Received by OCL	U.S. Department of the Interior BUREAU OF LAND MANAGEMENT		Sundry Print Repor		
	Well Name: NV NAVAJO 24	Well Location: T29N / R14W / SEC 24 / SESW / 36.7068502 / -108.263438	County or Parish/State: SAN JUAN / NM		
	Well Number: 3	Type of Well: OTHER	Allottee or Tribe Name: SHIPROCK		
	Lease Number: 14206032198A	Unit or CA Name: FRCL - W/2	Unit or CA Number: NMNM127966		
	US Well Number: 3004531423	Well Status: Producing Gas Well	Operator : HILCORP ENERGY COMPANY		
l	x

HILCORP ENERGY COMPANY NV NAVAJO 24 3 NOTICE OF INTENT TO PERMANENTLY ABANDON				
	API #: 3004531423				
	JOB PROCEDURES				
7 7	NMOCD Contact OCD and BLM/Navajo 24 hrs prior to MIRU. Comply with all NMOCD, BLM & Navajo, and HEC safety and BLM/Navajo environmental regulations.

CONDITIONS OF APPROVAL

BLM FFO Fluid Minerals P&A Geologic Report

HILCORP ENERGY COMPANY NV NAVAJO 24 3 NOTICE OF INTENT TO PERMANENTLY ABANDON

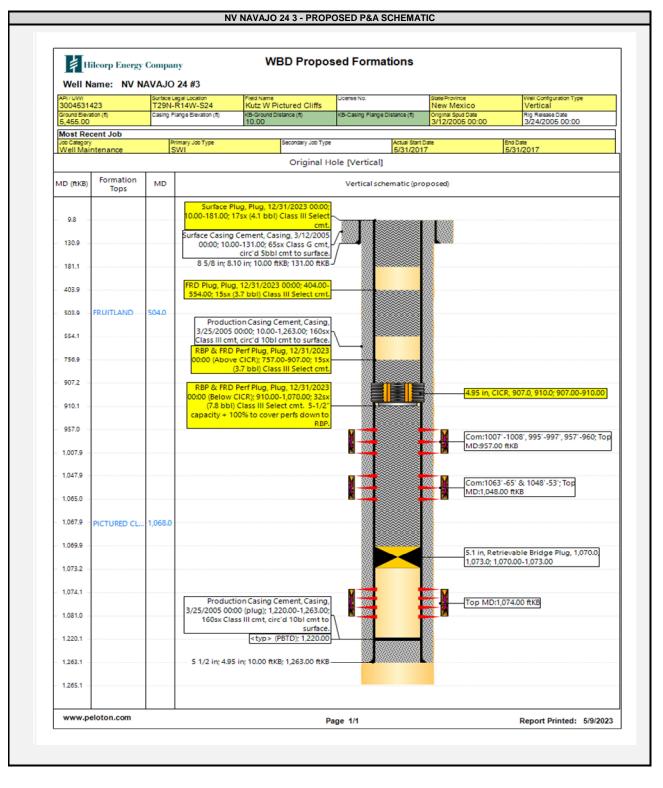
- 1. Plugging operations authorized are subject to the attached "General Requirements for Permanent Abandonment of Wells on Federal and Indian Lease."
- The following modifications to your plugging program are to be made:
 a. Adjust Plug #1 to cover BLM Fruitland formation top @ 694'.
- 3. Farmington Office is to be notified at least 24 hours before the plugging operations commence at (505) 564-7750.

Remarks:	Reference Well:
- Pictured Cliffs perfs 1074' - 1081'. Fruitland coal perfs 957' - 1065'.	1) Formation Tops
	Same
- Adjust Plug #1, or add a plug, to cover BLM Fruitland top @ 694'. Proposed Plug #2	
covering Operator Fruitland top can be omitted.
